CONDITION OF CONCERN

Recall 1017E – Fuel Leak at Fuel Pump Discharge Pipe:

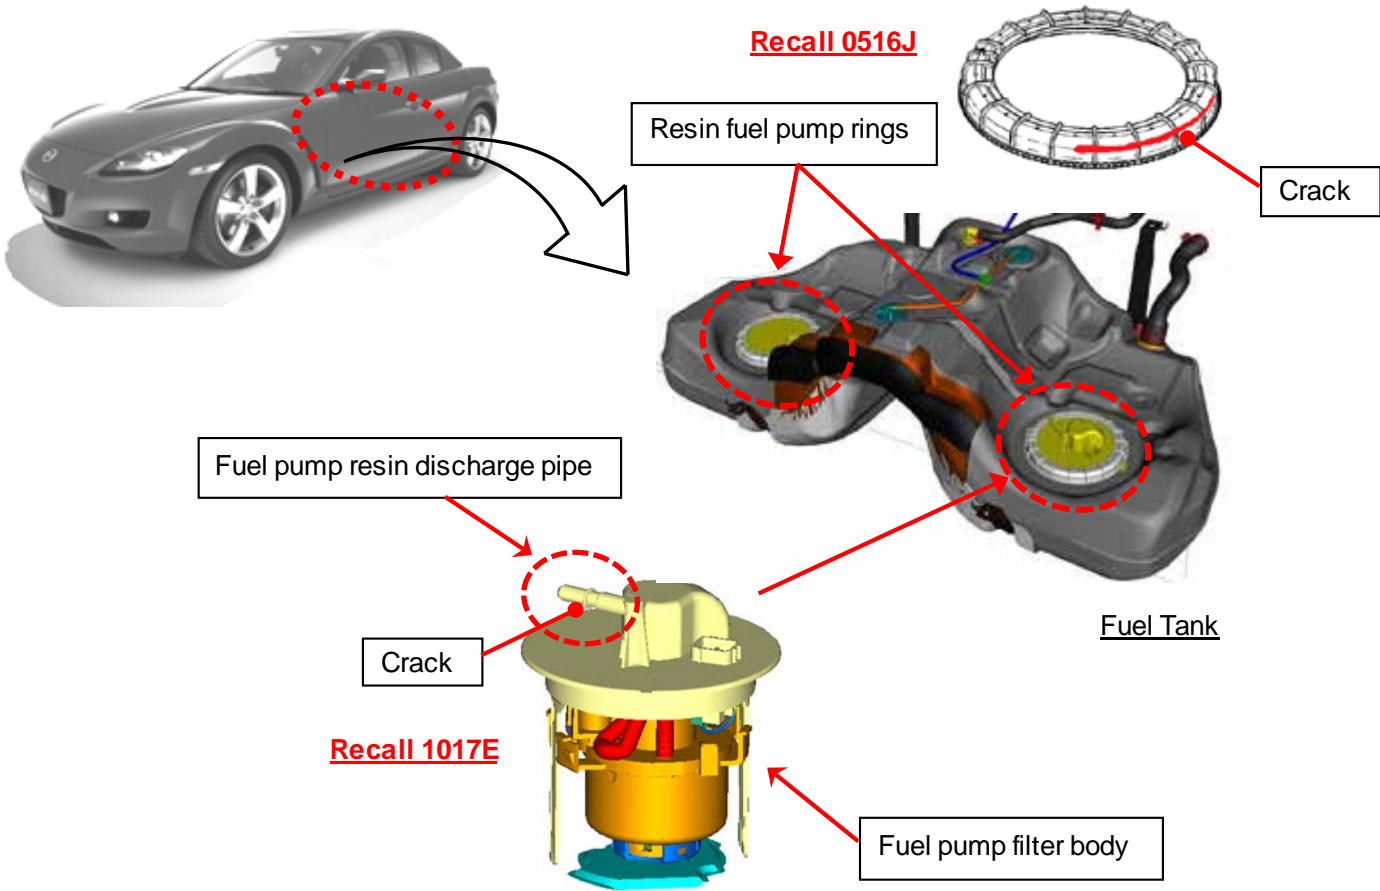
Due to insufficient durability of the resin discharge pipe of fuel pump, the discharge pipe may deteriorate, affected by the pressure of fuel inside the pipe and by heat from the engine and exhaust pipe. Continuous use of the vehicle may allow the deterioration of discharge pipe to progress, leading to a crack in the discharge pipe and subsequent fuel leak, which may increase a risk of fire.
